## Attachment II – Technical Comments

30. Provision C.3.d. (2)(c) – 0.2-inch/hour Flow Design Basis

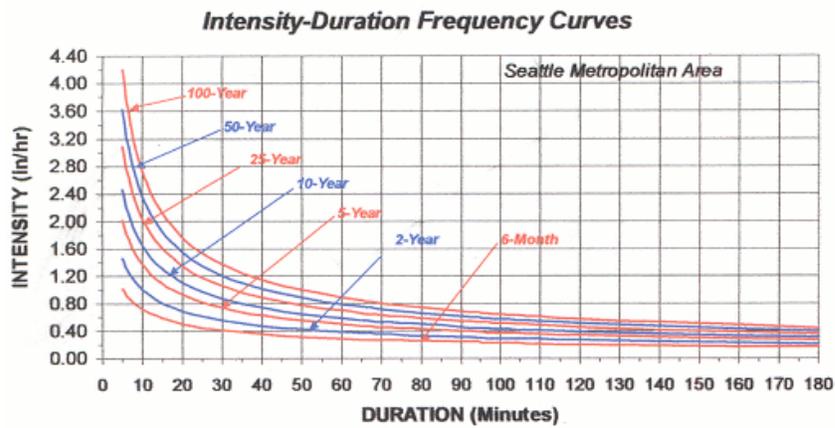
Guidance is needed on the interpretation and application of the 0.2-inch per hour flow based criteria when sizing storm water treatment systems designed for small LID catchments where times of concentration are less than 5-minutes. It is not clear from the criteria if the intent is to design for storm events with an average storm intensity of 0.2-inch/hour or to design a system using a maximum uniform intensity of 0.2-inch/hour. The two are vastly different and produce BMPs that may be either slightly oversized or significantly undersized depending on which interpretation of the criteria is used.

The 0.2 inch/hour criteria used by the Water Board is also contained in the CASQA BMP Handbooks and was developed in the San Diego Region which has significantly different rainfall depths, storm durations and number of annual events, but similar short-duration intensities to the Bay Area. It is based on 51-years of hourly rainfall data collected at the San Diego Airport rain gauge. They found that 85% of the storm events have an intensity that is less or equal to 0.1 inch/hour. That intensity was multiplied by two to provide a margin of safety to allow for the possibility that some rain which falls during an hour could have fallen in bursts of greater intensity than 0.1 inch/hour.

Studies and data presented by NOAA indicate that these short-duration high intensity periods have rainfall intensities significantly greater than 50 and 100-year hourly intensities as indicated in the following graph developed for the City of Seattle.
